# 7ELEVEN AT WALLBROOK (LOT 11)

## SITE DEVELOPMENT PLAN

**7ELEVEN AT WALLBROOK (LOT 11)**  
Town of Rolesville Project No. SDP 23-\_\_\_\_  
US 401 Business / S. Main Street & Virginia Water Drive  
Wake Forest Township, Town of Rolesville, Wake County, North Carolina

**Final Drawing - Issued for Permit Review Purposes Only**

**COVER - OVERALL SITE PLAN**

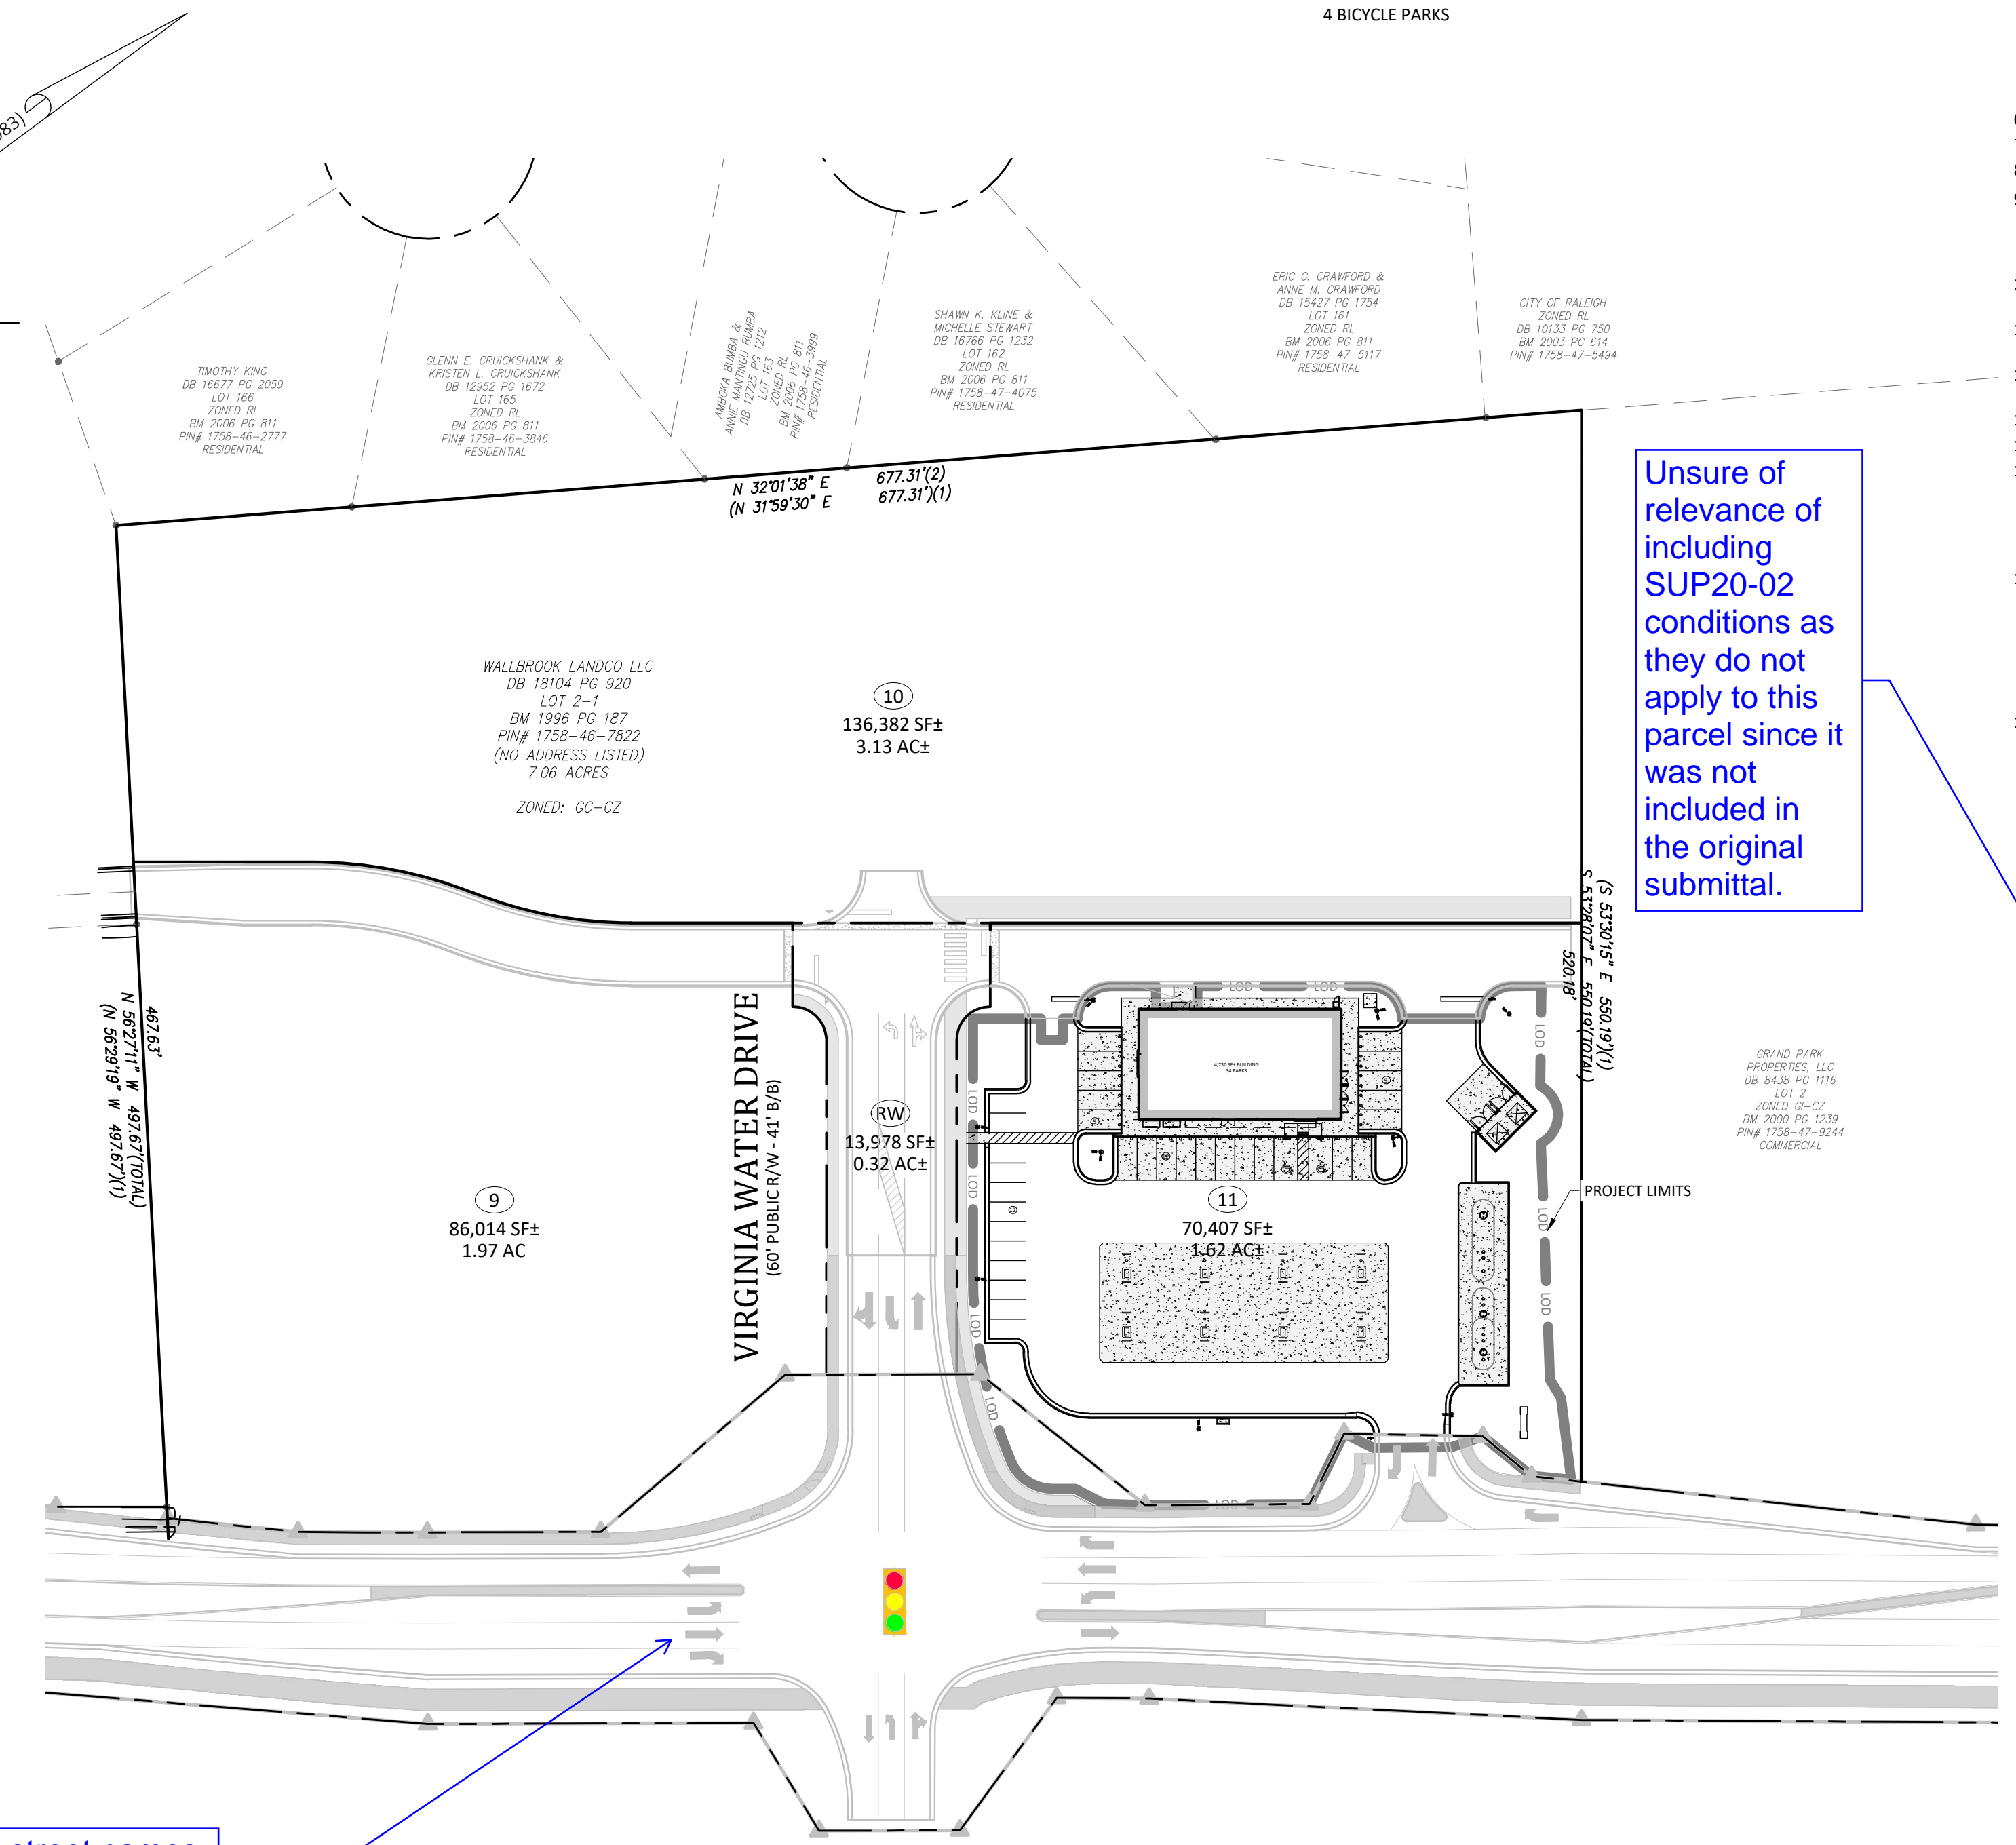
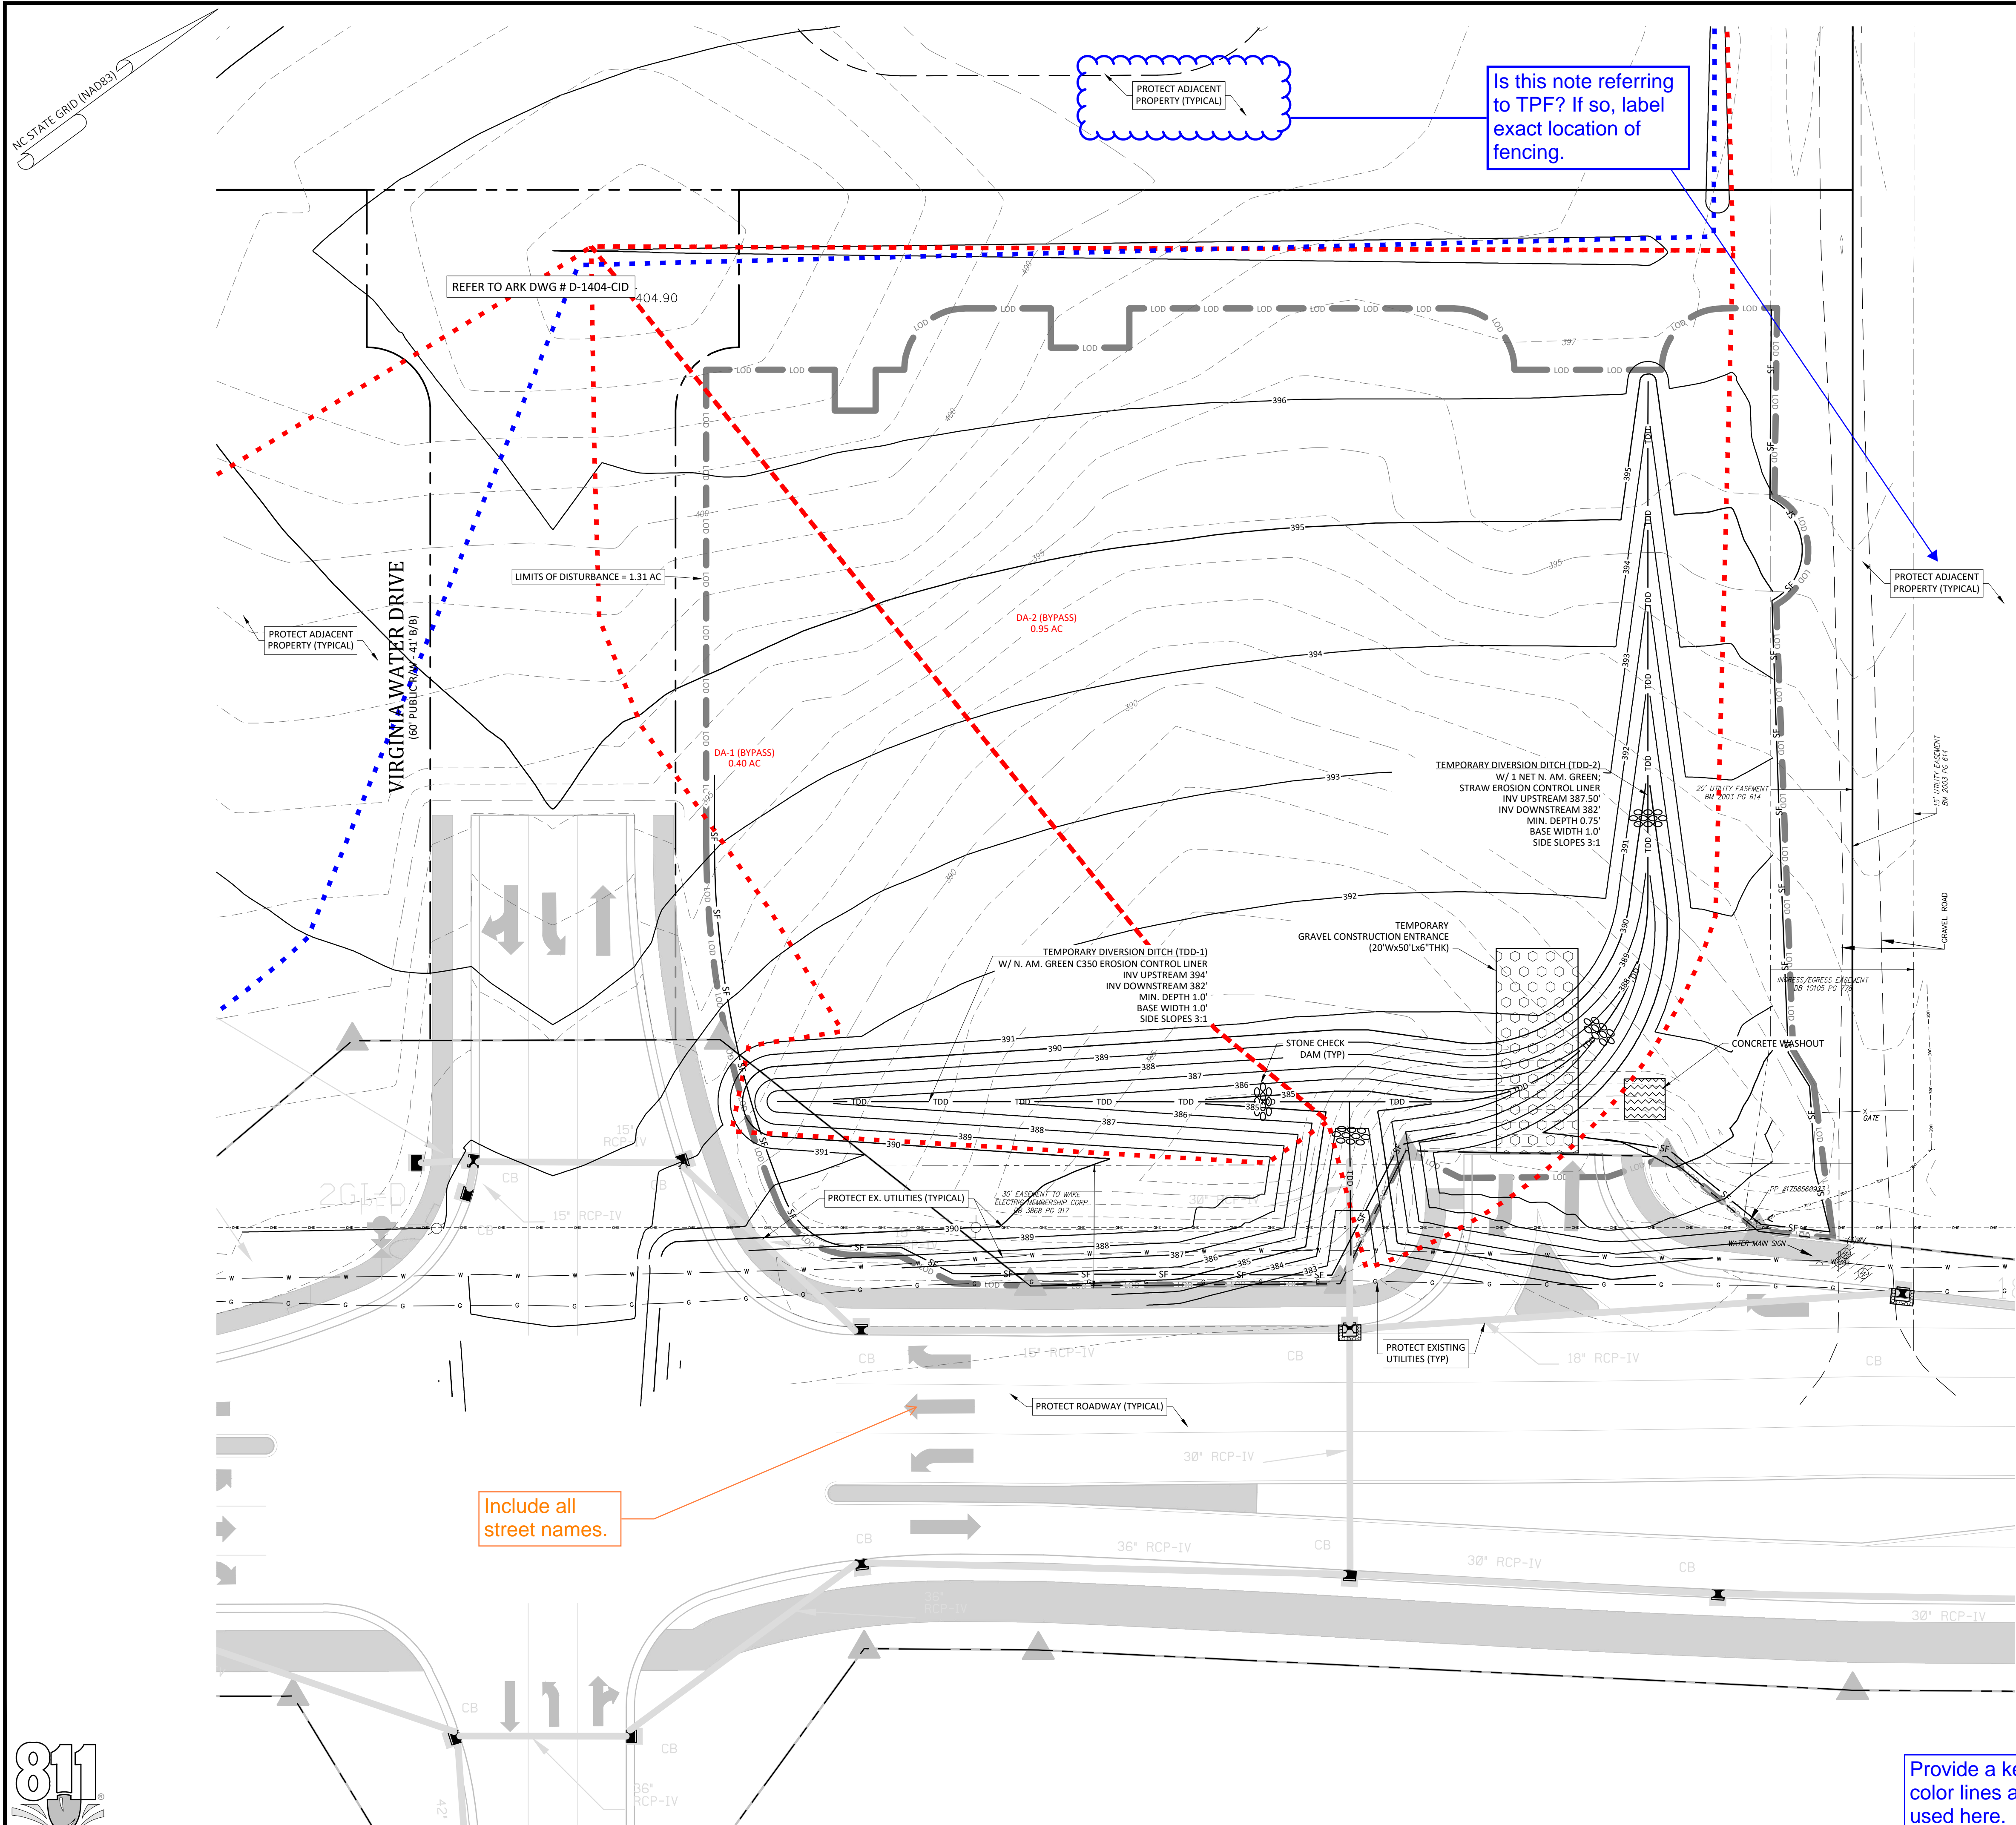
Add site plan number SDP-23-04 to the cover sheet.

Add setbacks and open space required and demonstrate compliance

Update FIRM map to include the most recent dates/numbers.

Please provide a existing conditions sheet including tree preservation area consistent with PR21-04 REV.

Please provide a lighting plan sheet compliant with LDO Section 6.6.F and 6.6.M

Include street names here, including ROW width and Book and Page number.

Unsure of relevance of including SUP20-02 conditions as they do not apply to this parcel since it was not included in the original submittal.

Include date of drawing.

**EROSION CONTROL PLAN - PH. 1**  
**7ELEVEN AT WALLBROOK (LOT 11)**  
Town of Rolesville Project No. SDP 23-  
US 401 Business / S. Main Street & Virginia Water Drive  
Wake Forest Township, Town of Rolesville, Wake County, North Carolina

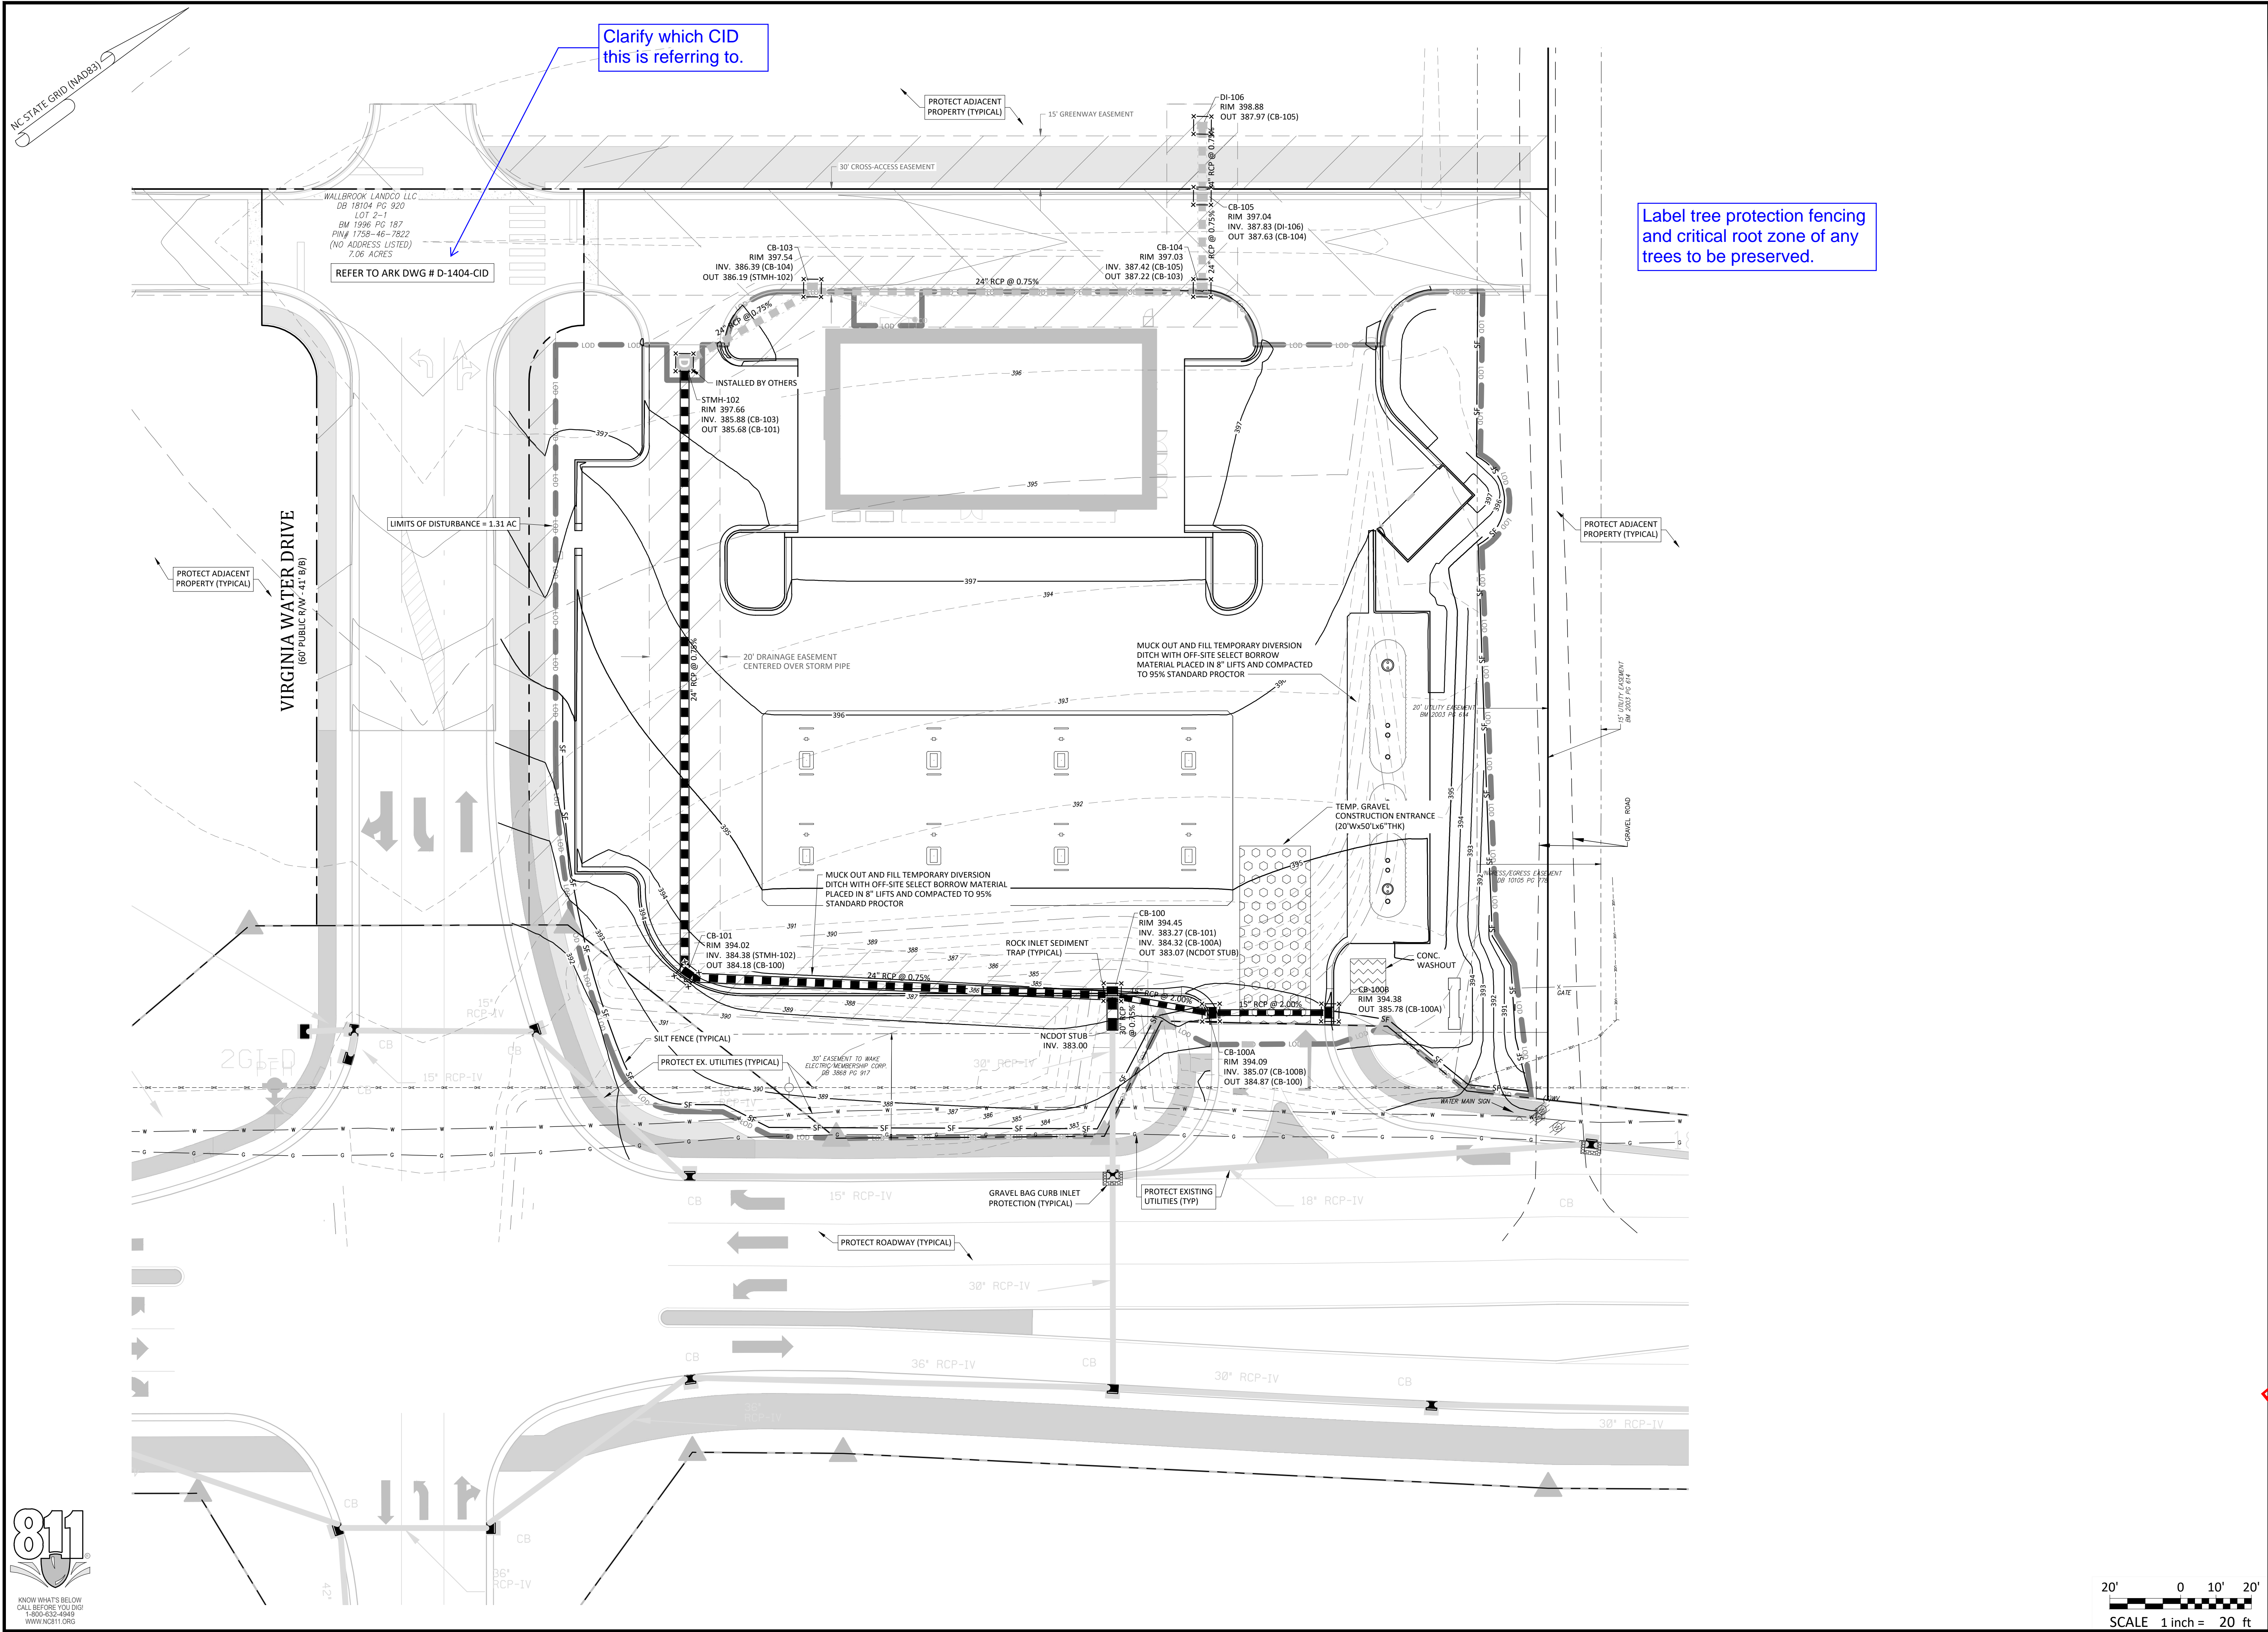
Include all street names.

Is this note referring to TPF? If so, label exact location of fencing.

Provide a key/legend for the different color lines and symbols shown and used here.
